1. Section Line Easement Vacation; KPB File 2022-060V

Vacate the section line easements associated with Tracts A, B & C of Quartz

# COOPER LANDING ADVISORY PLANNING COMMISSION REGULAR MEETING LOCATION: ZOOM TELECONFERENCE OR COOPER LANDING COMMUNITY HALL WEDNESDAY, JUNE 08, 2022 6:00 PM

**UNAPPROVED MINUTES**

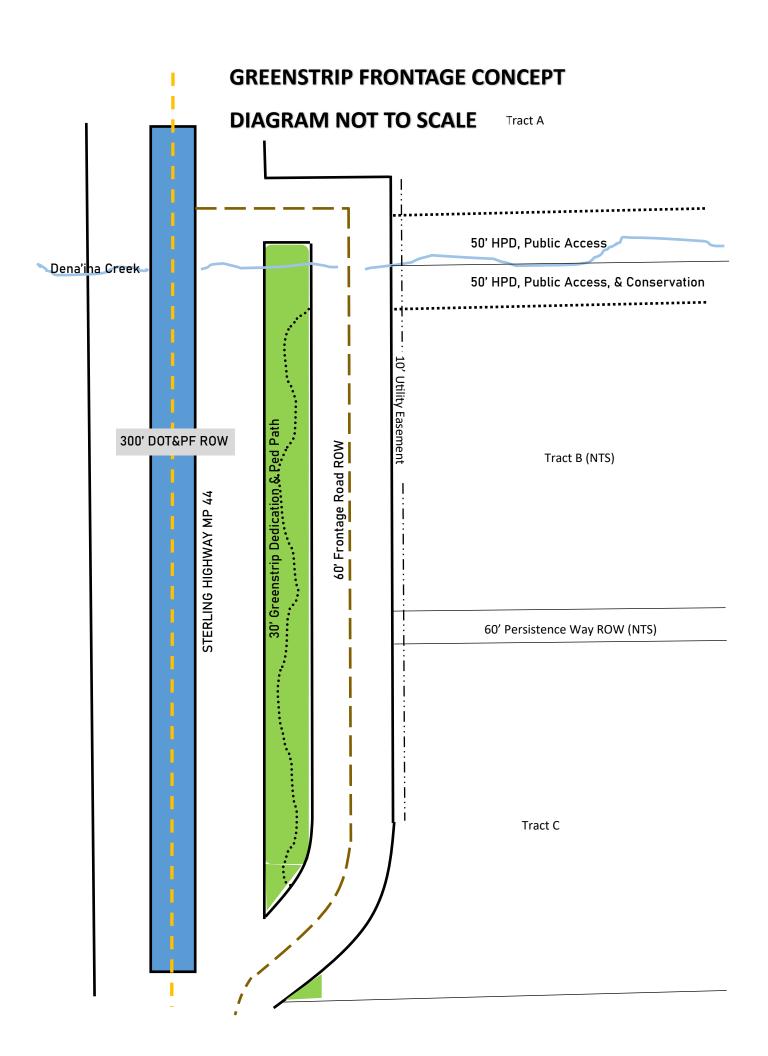
- a. R. Ruffner said that the 30' greenbelt proposal would come out of tracts C and B.
- 13. The KPB conceptual design was presented on Zoom which shows that there is a 30' green-strip that is at the top [Sterling Hwy side] of those parcels while the 60' frontage road would be on the non-highway side of the green-strip.

- 39. D. Steiner said he wants to make sure everyone knows what is being proposed and asked to show the design plan.
  - a. There is a conservation easement that surrounds the property. Three Bears would like to abandon the conservation easement on the back of the lot (south border) and along Persistent Way (west border) in exchange for maintaining the frontage road and 30' greenspace concept as presented by the KPB drawing.

- 40. C. Degernes moved to recommend approval of the preliminary plat 2022-060 subject to maintaining the 30' greenspace concept as presented by the KPB drawing and agreed to by Three Bears, and provided the original 50' conservation easement along Denaina Creek is maintained. L. Johnson seconds. All approve by roll call vote.

- b. Section Line Easement Vacations on Tracts A, B, C Quartz Creek Subdivision
  - i. C. Degernes moves to support the vacation of section line easements assuming the approval of the 2022-060 Preliminary Plat subject to the 30' greenspace concept as discussed. H. Harrison seconds. All approve by roll call vote.
